Staff comments:
Staff and applicant have discussed the following with respect to the landscape plan:

DALLAS ISD
ORG 174 GENEVA HEIGHTS ELEMENTARY
5895 GOODWIN AVE.
DALLAS TX 75206

L2.01

LANDSCAPE PD EXHIBIT

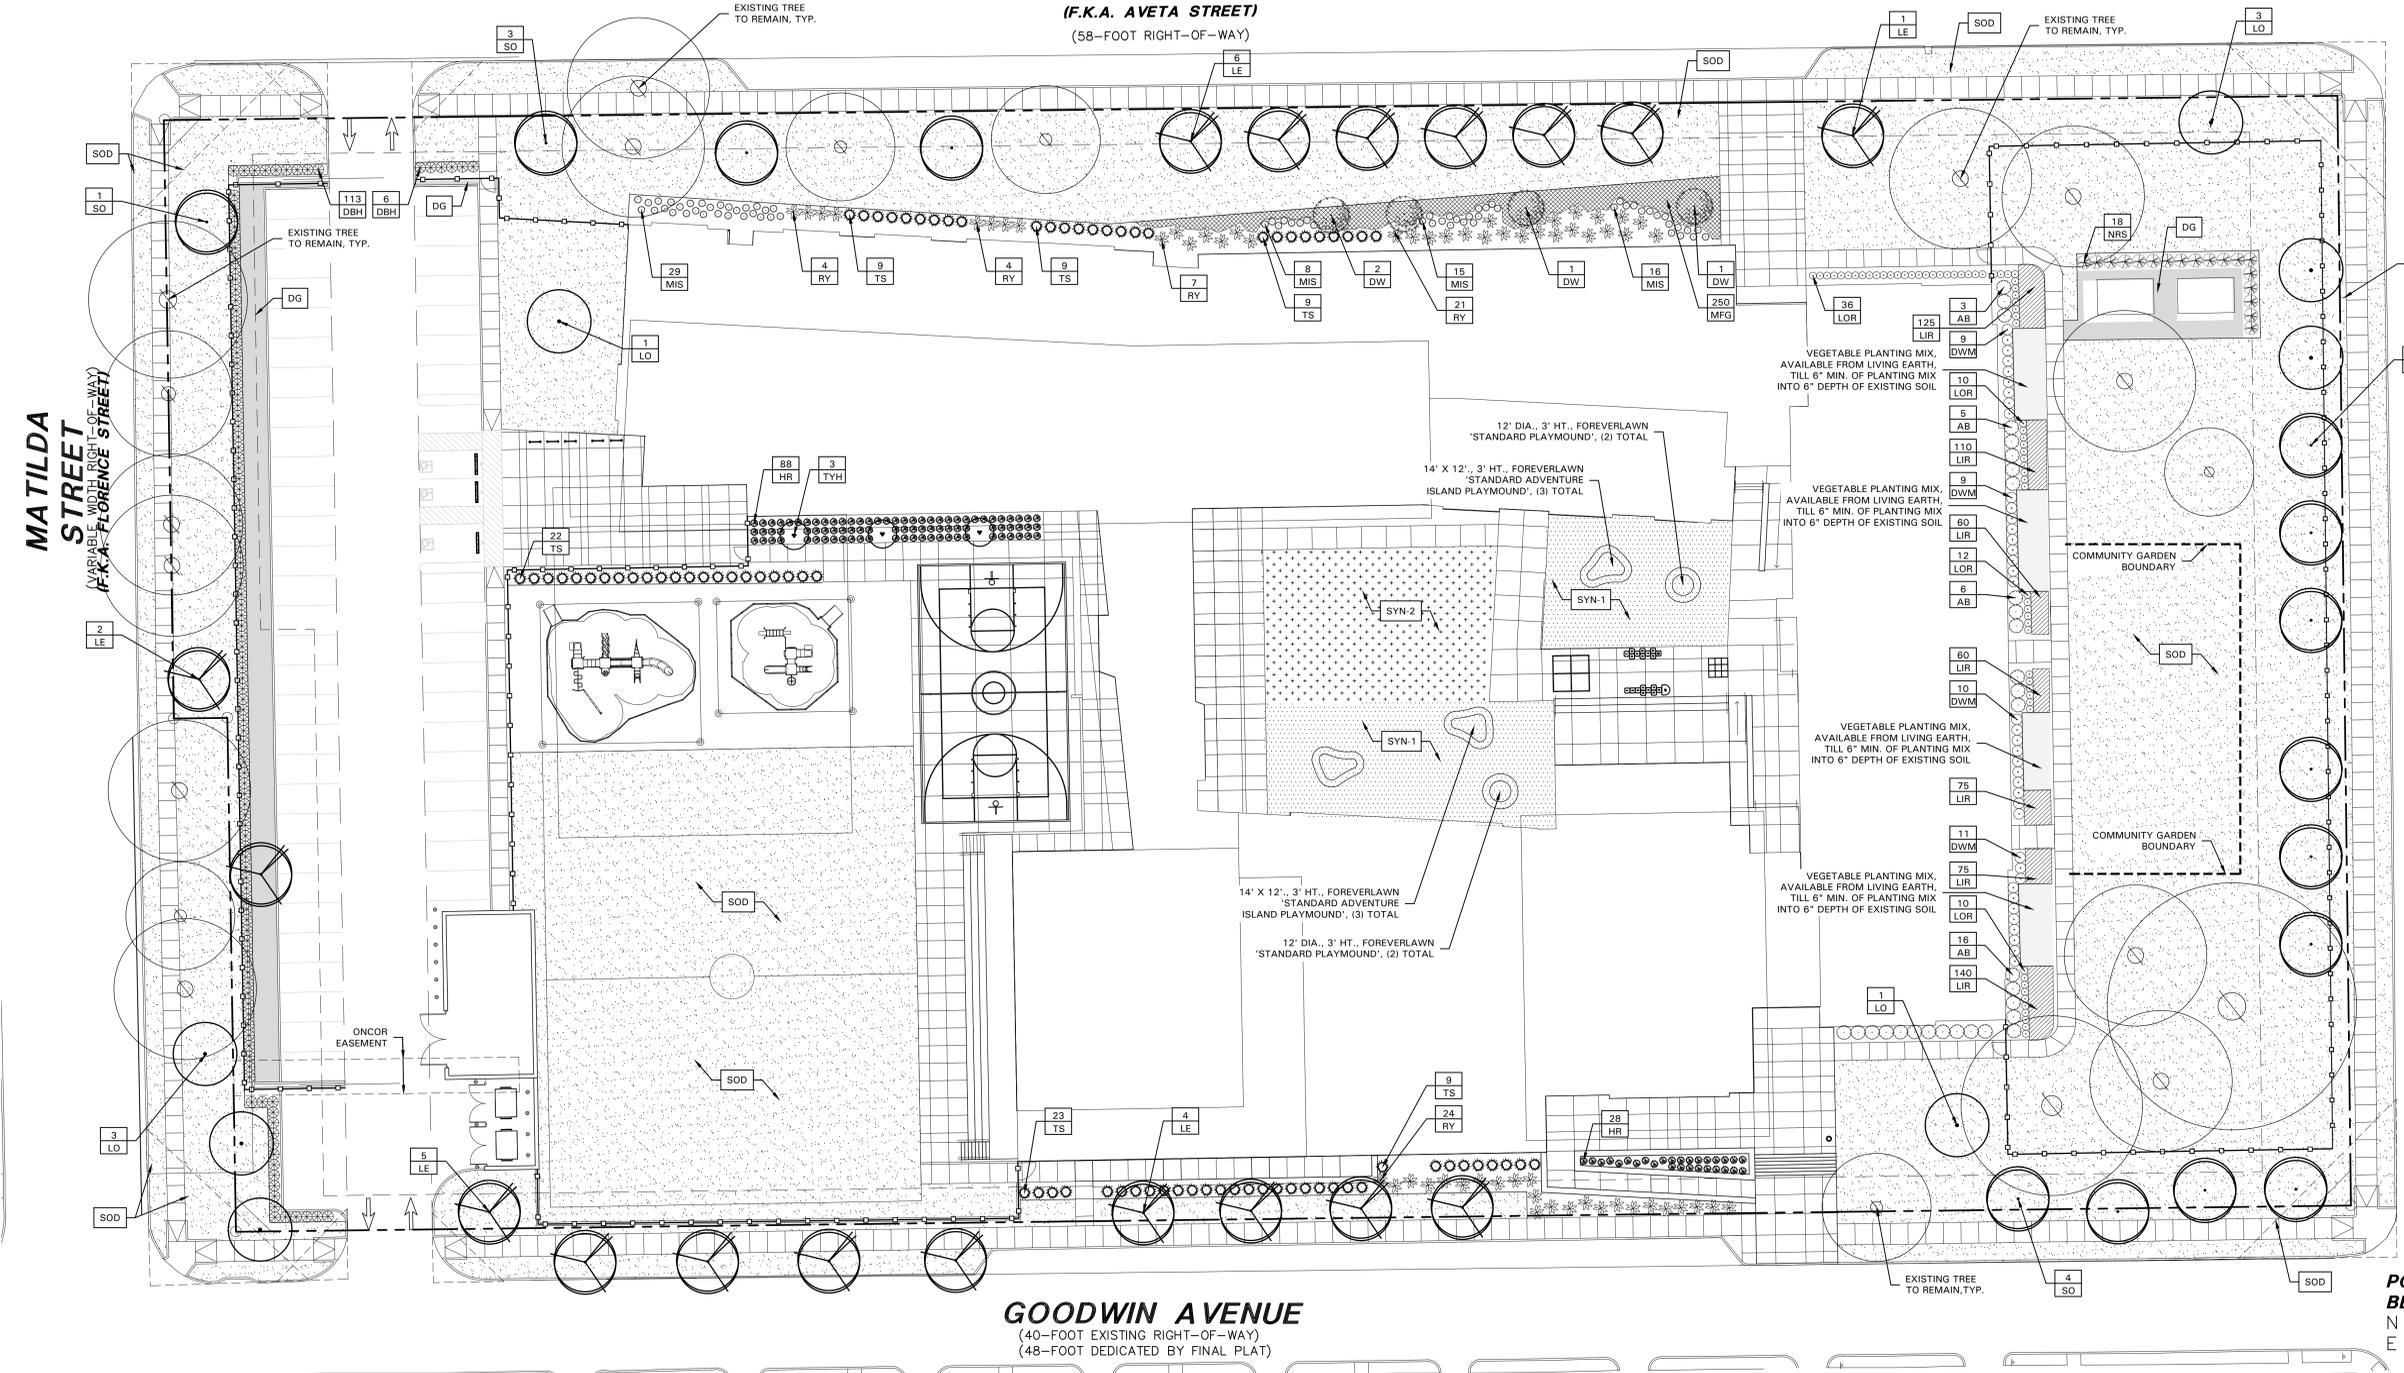
1. Where LA plan shows conflict between sidewalk and existing trees, engineering and arborist staff will work with applicant at permitting to ensure that sidewalks are located so as not to harm existing trees, while also conforming to the text of the ordinance

Staff comments, cont'd:

--> width reduction for sidewalk/buffer along Matilda Street (allowed per text of ordinance) will be utilized to ensure protection of existing trees along this frontage

--> sidewalk/buffer width is not to be reduced along the ENTIRE length of Matilda Street frontage, just where necessary to avoid an existing tree

--> minimum buffer required per text of ord does not preclude an increase in buffer width where necessary to avoid existing trees

2. Minor revisions to LA plan needed for consistency with dev plan (prior to CC)

--> text of ordinance controls over these exhibits, so LA and dev plans will not need to be amended in order to make these minor adjustments
